# Service Bulletin No. 382

MODEL E / J Series Coaches	TYPE Field Change Program	SECTION/GROUP 3- Body	DATE Mar. 6, 2012
SUBJECT PARCEL RACK ROOF FASTENERS			
CONDITIONS

Figure 1.

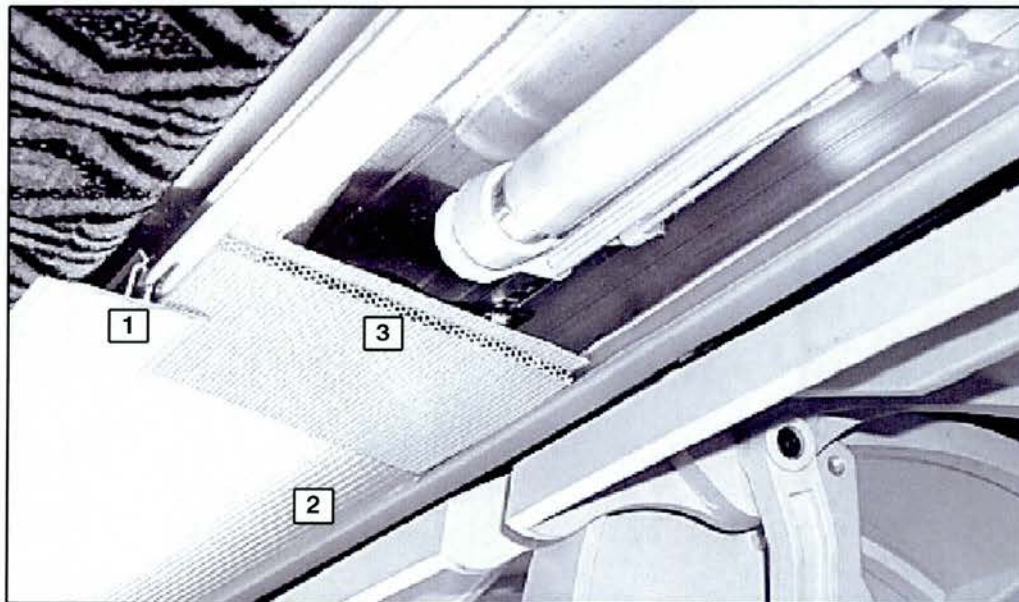
- Using masking tape, label the position of the the vinyl ceiling panel covers, the aisle light lens cover and the speaker grills for re-installation.
- Carefully remove and retain the vinyl ceiling panel covers, the aisle light lens covers and the speaker grills ( refer to Figure 1 ).

**Figure 3.**

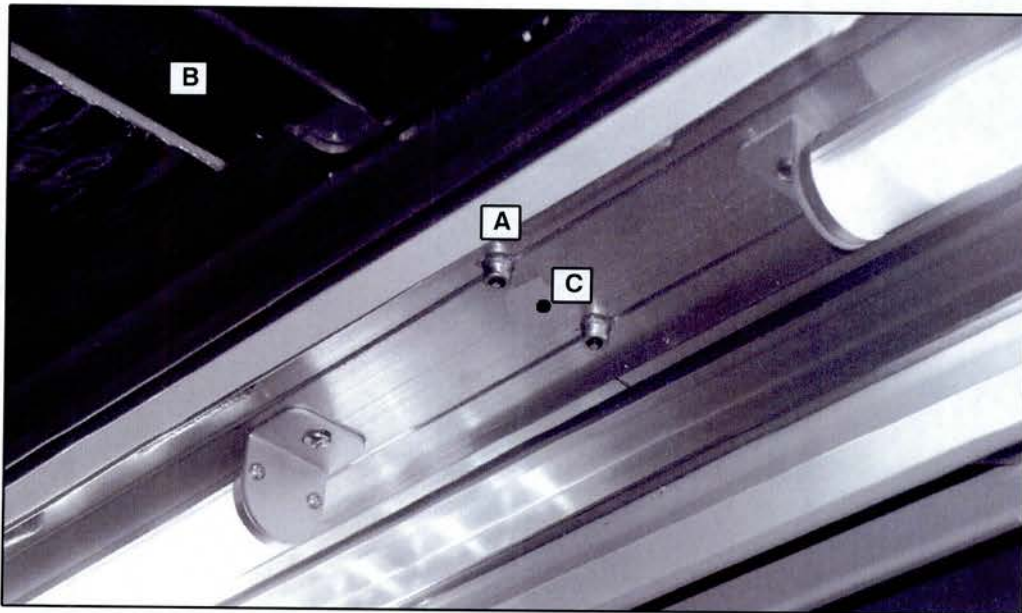
- Locate the existing rivets securing the aluminum extrusion to the roof bow steel tube ( refer to Figure 2 ).
- Using a 9/32 drill bit, drill a hole centered between the existing rivets through the aluminum extrusion and the roof bow steel tube ( refer to Figures 2 and 3).

7. Using the new rivet, p/n 19-13-255, rivet the aluminum extrusion to the roof bow stainless steel tube.
